1997 - 2002 Corvette: Service Bulletin: SMU - Revised Side Cover and Gasket Replacement (RH)/Differential Carrier Cover and Seal Replacement

Number: 02-04-20-003

Date: 07-18-2002

Subject: SMU - Revised Side Cover and Gasket Replacement (RH)/Differential Carrier Cover and Seal Replacement - Right

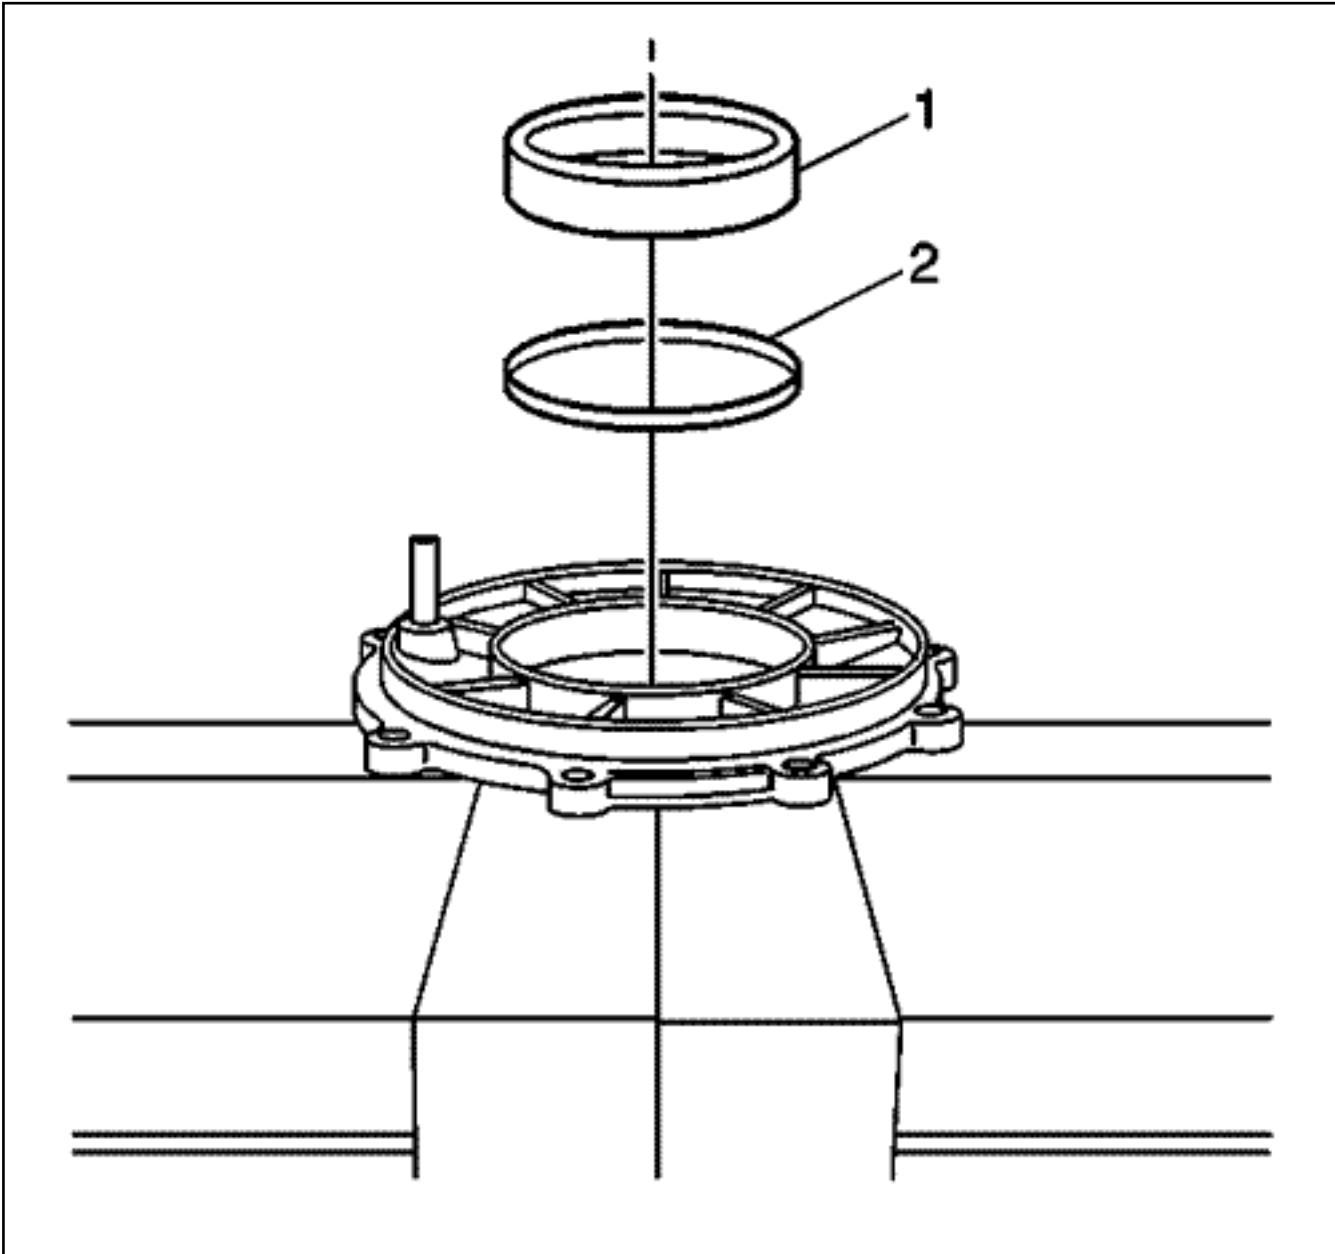
Whenever service requires the replacement of the right side differential cover, the covers MUST be measured and the right side shim pack adjusted to compensate for machining tolerances between the two components. Failure to perform this measurement procedure may result in improper differential bearing preload.

13. Use a caliper (2), a straight edge (1), and J 42168-16 (3) in order to measure the NEW differential cover bore dimension. Record the measurement as value A.
14. Use a caliper (2), a straight edge (1), and J 42168-16 (3) in order to measure the old differential cover bore dimension. Record the measurement as value B.
15. Subtract value B from value A. If the computation is a positive value, add shims equal to the value, to the existing shim pack. If the computation is a negative value, subtract shims equal to the value, from the existing shim pack.
